# MONITORING YEAR 3 ANNUAL REPORT

## HENRY FORK MITIGATION SITE

Catawba County, NC  
DEQ Contract No. 005782  
DMS Project No. 96306

RE: **Response to MY3 Draft Report Comments  
Henry Fork Mitigation Project**  
DMS Project # 96306  
Contract Number 005782  
RFP Number 16-005298  
Catawba River Basin – CU# 03050103 Expanded Service Area  
Catawba County, North Carolina

### Cross-Section Plots

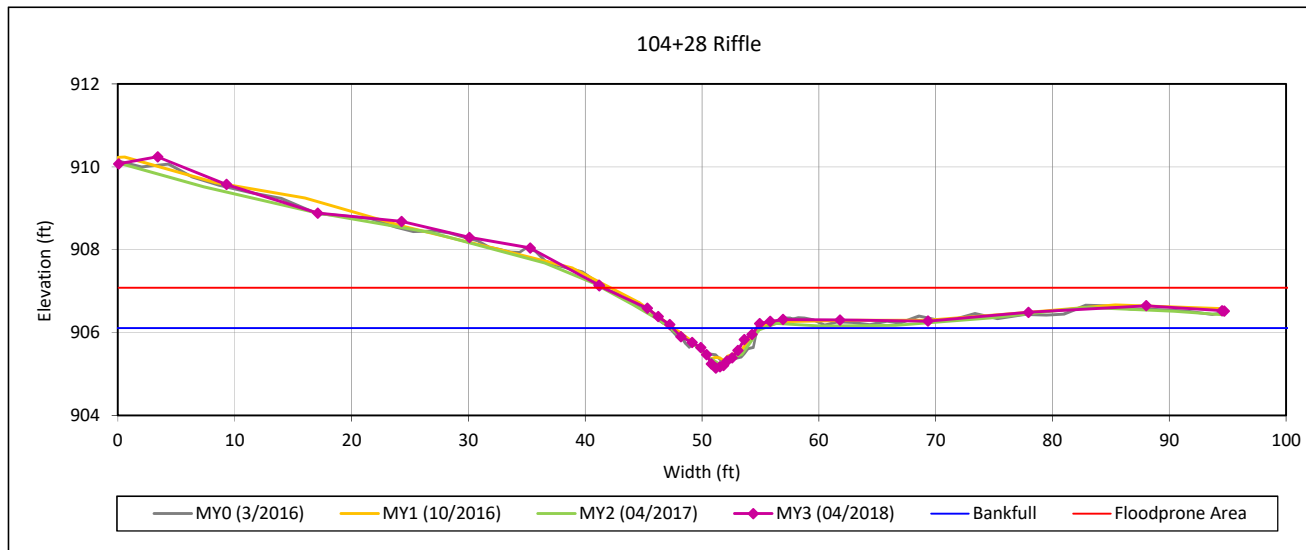
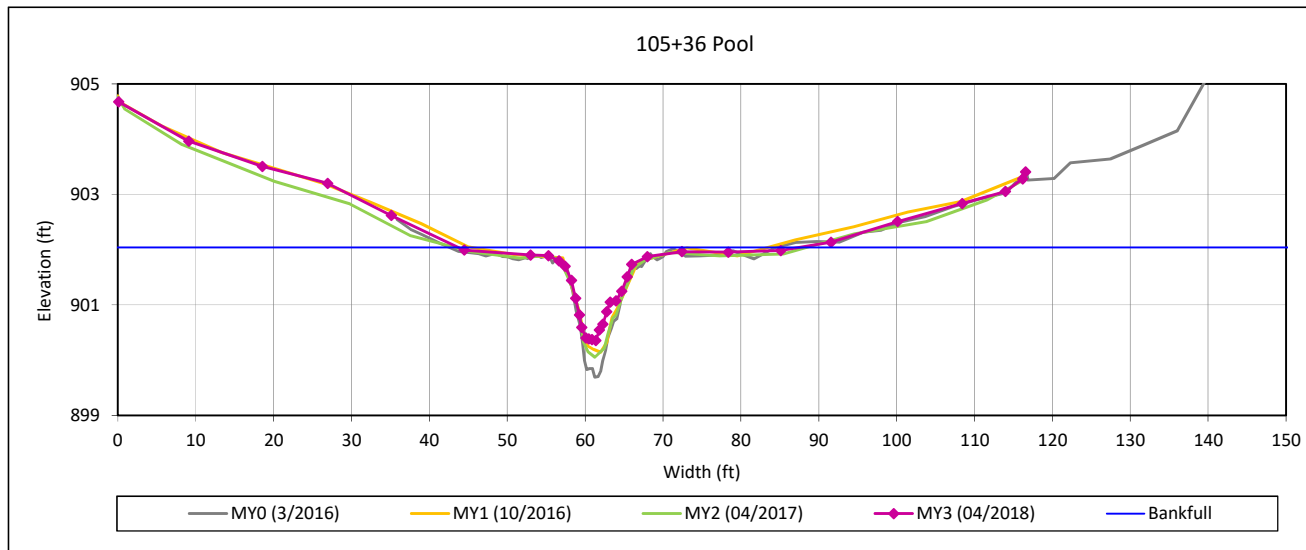
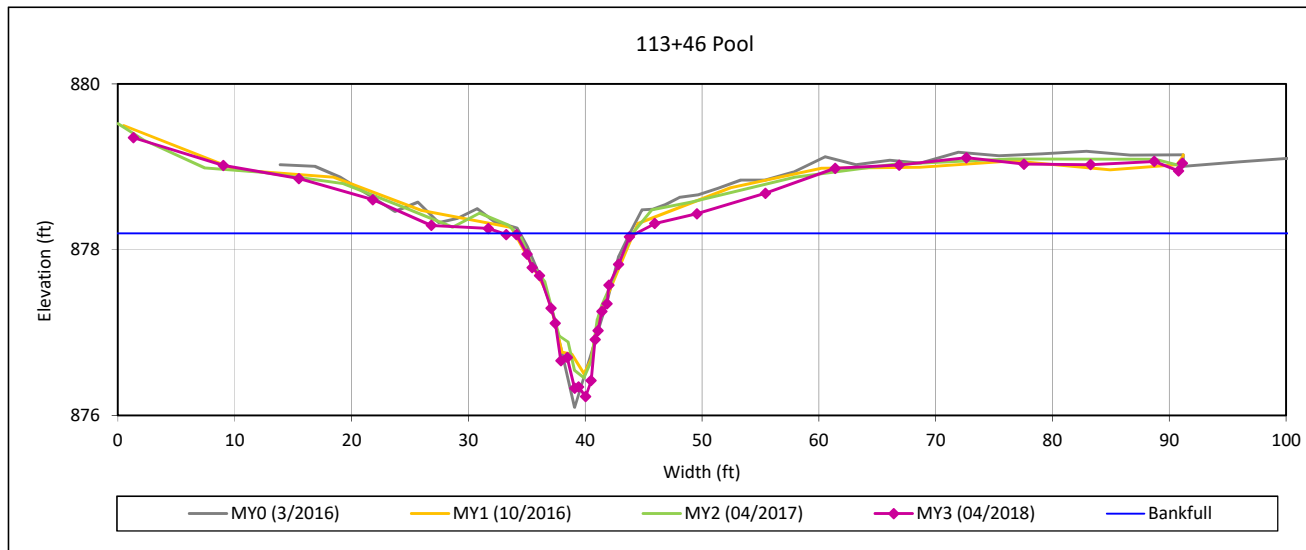
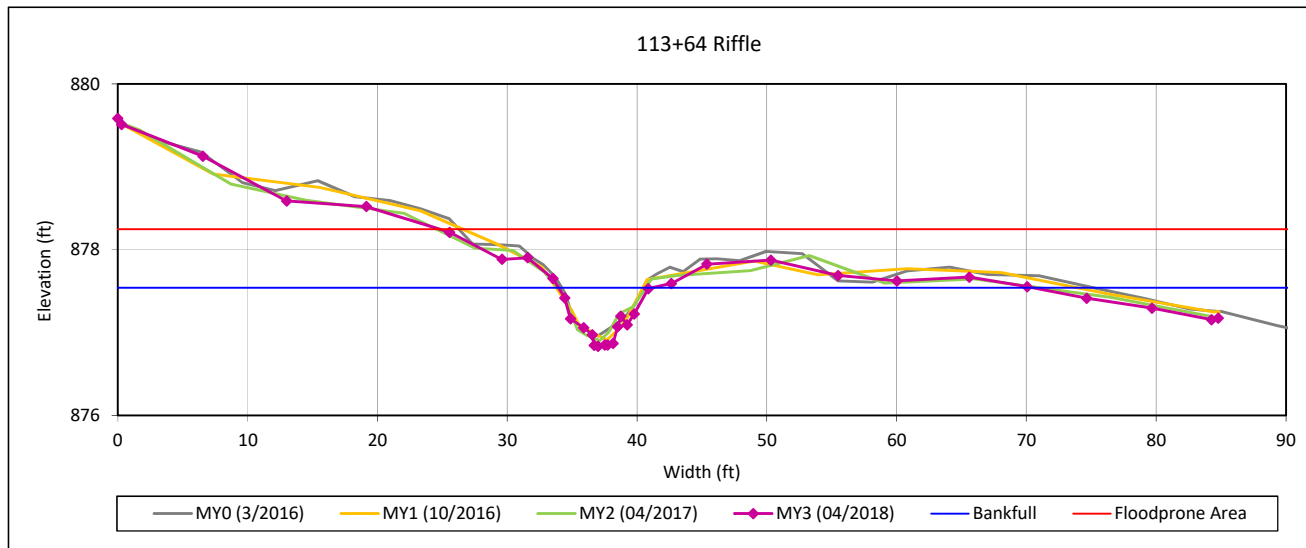
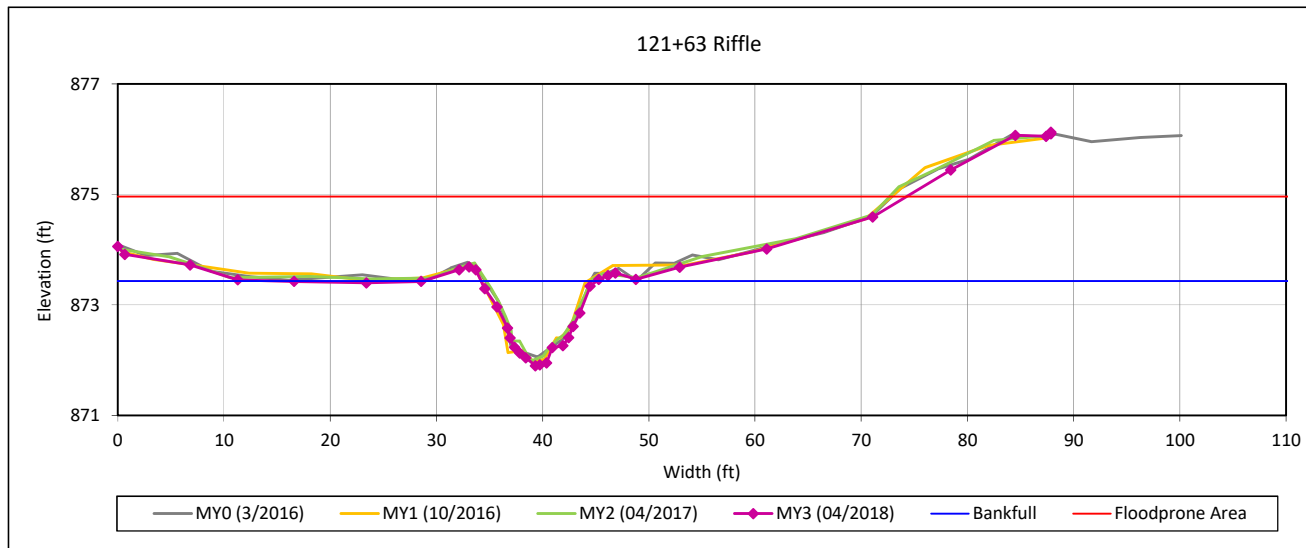
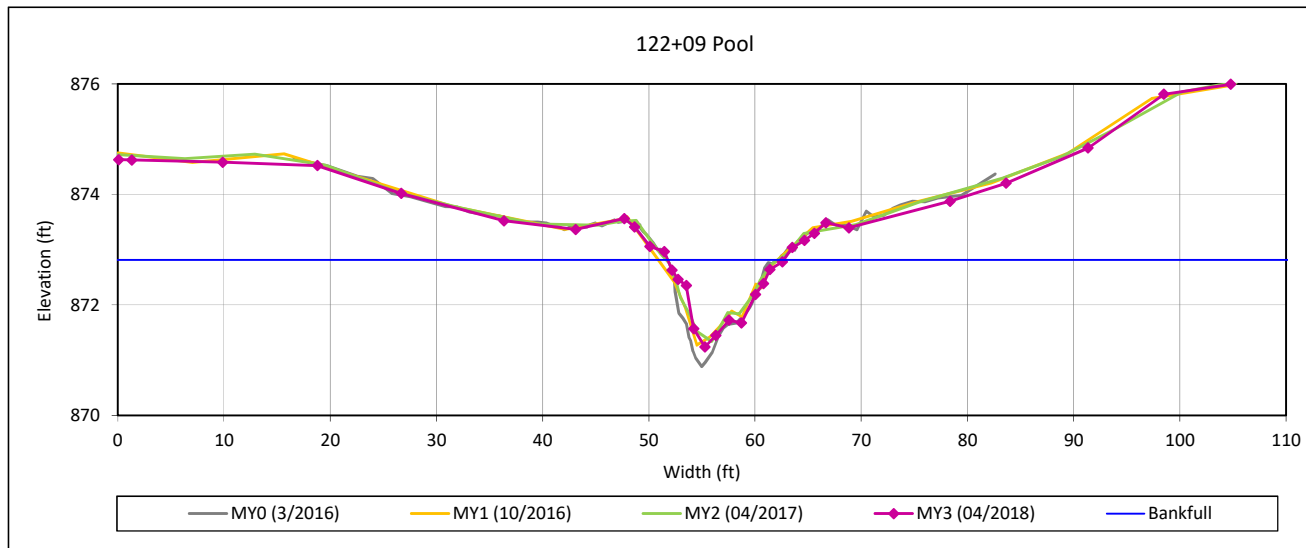
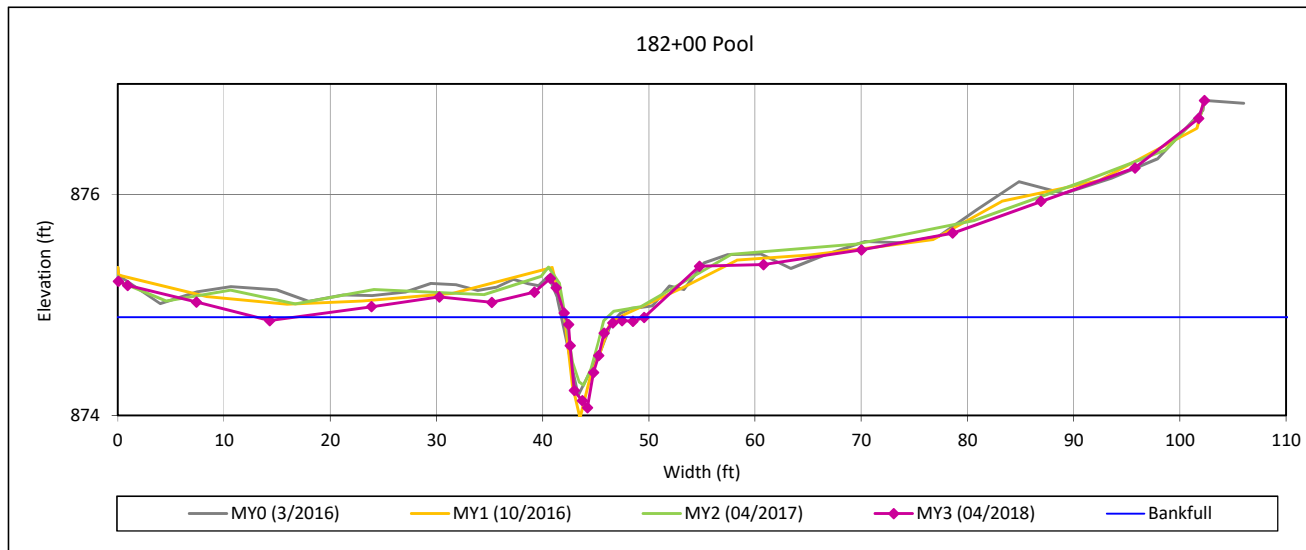
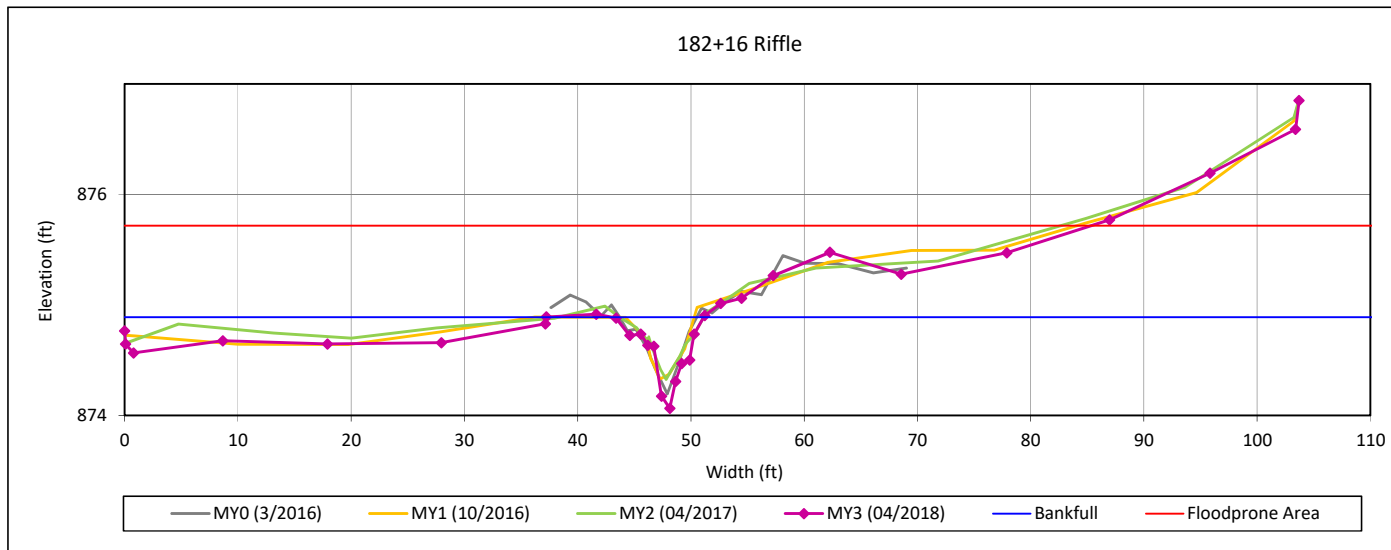
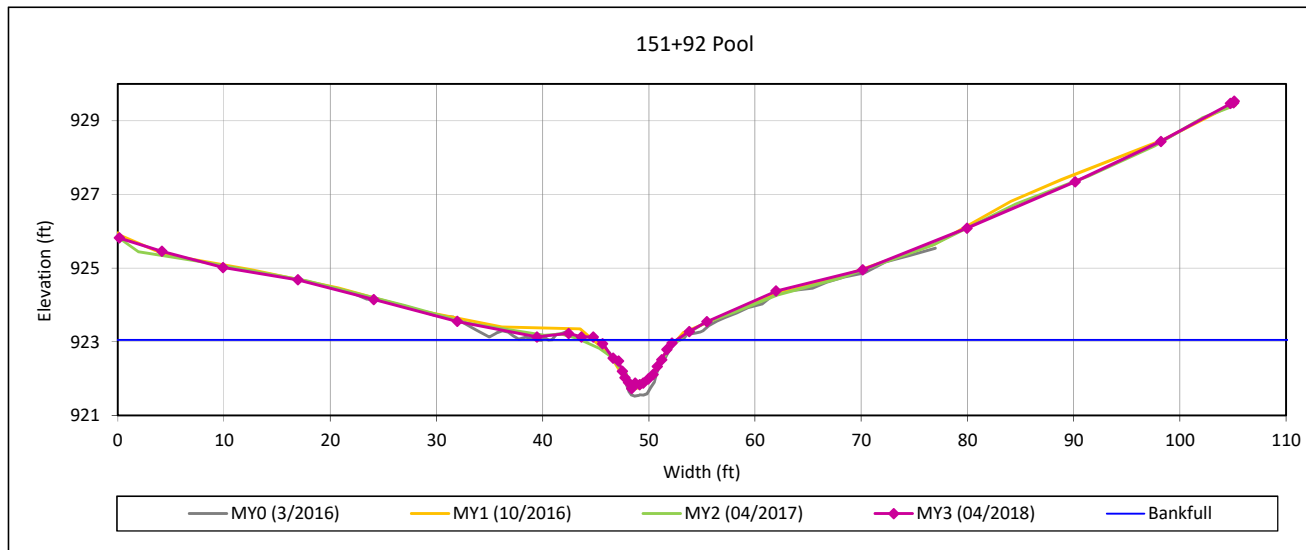
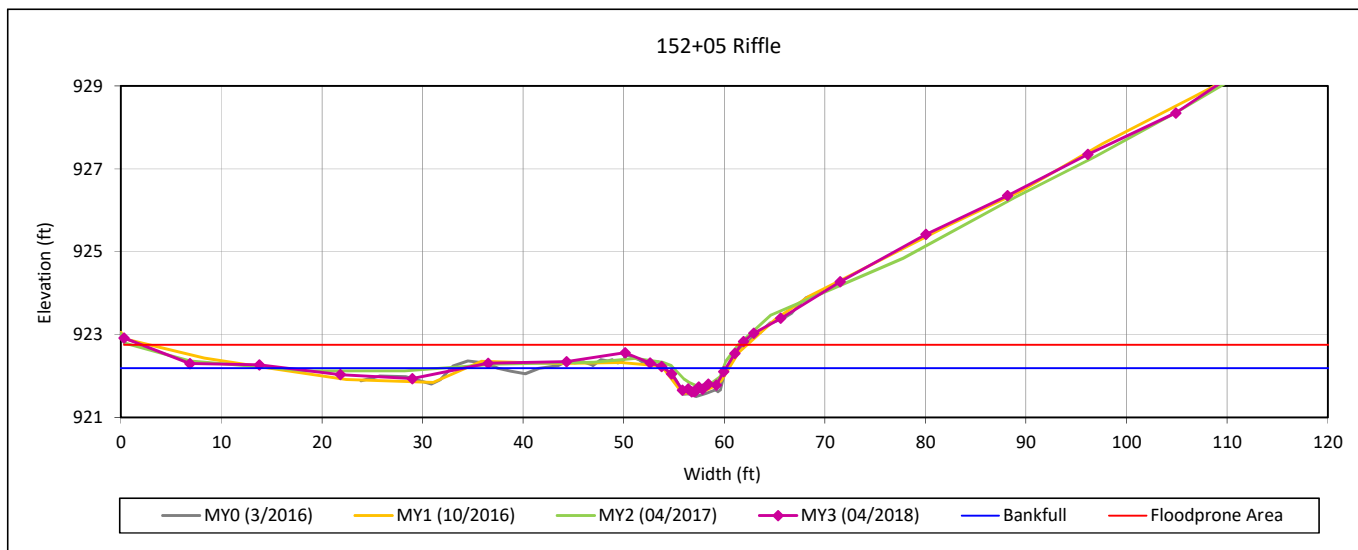
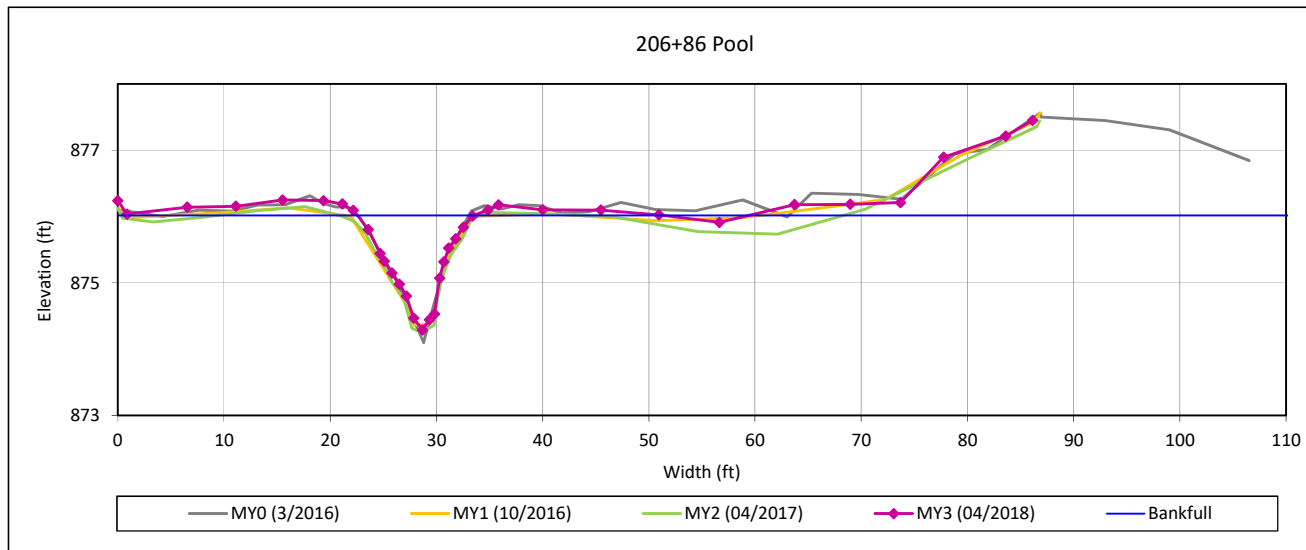
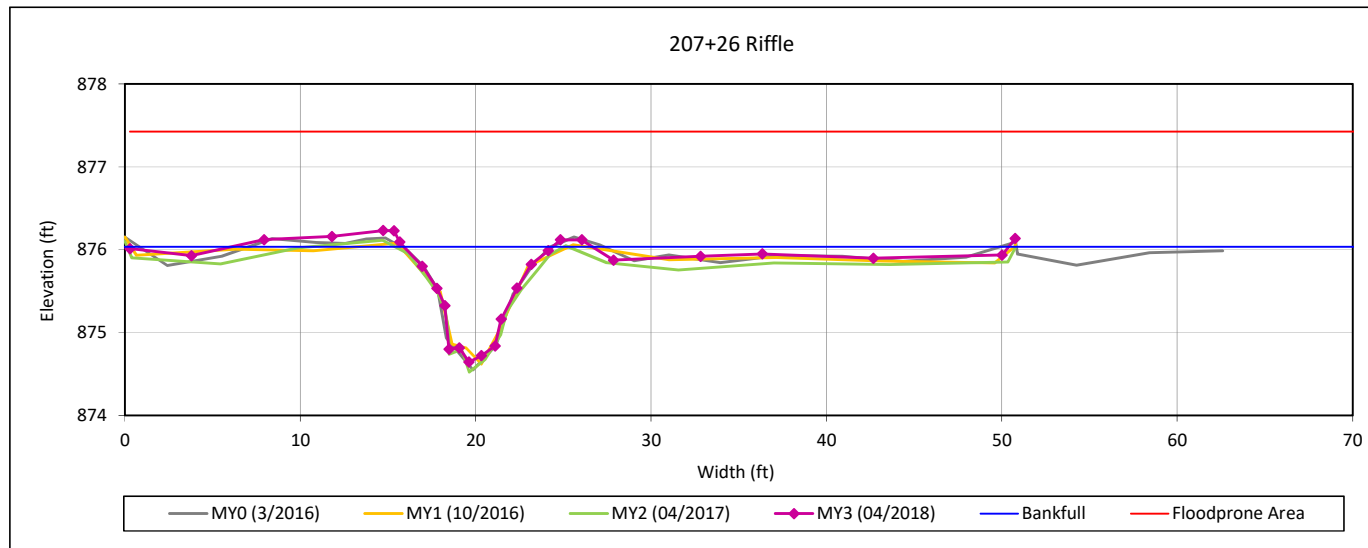
**DMS comment; Cross-sections: Please turn off marker for all monitoring years except MY3 to make graph more legible to reviewers.**

*Wildlands response; Wildlands has updated the cross-sections to remove markers for monitoring years prior to MY3.*
